**[Docket No. FAA-2017-0288; Product Identifier 2017-CE-007-AD]**

**Airworthiness Directives; Textron Aviation Inc. Airplanes**

**ACTION:** Supplemental notice of proposed rulemaking (SNPRM); reopening of comment period.

Figure 1 to paragraphs (k)(1)(iii) and (v) of this AD: Cross section of v-band coupling

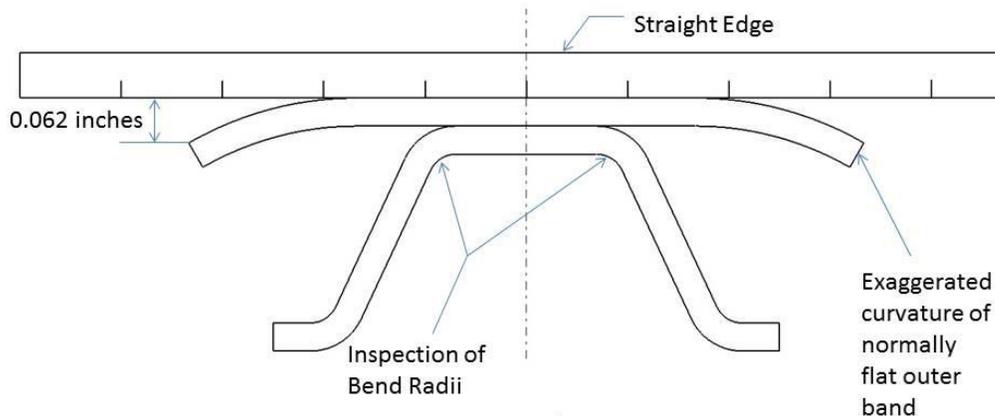
(iii) Visually inspect the flatness of the outer band using a straight edge. Lay the straight edge across the width of the outer band. The gap must be less than 0.062 inches. See figure 1 to paragraphs (k)(1)(iii) and (v) of this AD. If the gap exceeds 0.062 inches between the outer band and the straight edge, do not re-install the v-band coupling. Before further flight, you must install a new v-band coupling and restart the hours TIS for the repetitive replacement of the v-band coupling.

(v) Visually inspect the bend radii of the coupling v-retainer coupling segments for cracks. Inspect the radii throughout the length of the segment. See figure 1 to paragraphs (k)(1)(iii) and (v) of this AD. If any cracks are found, do not re-install the
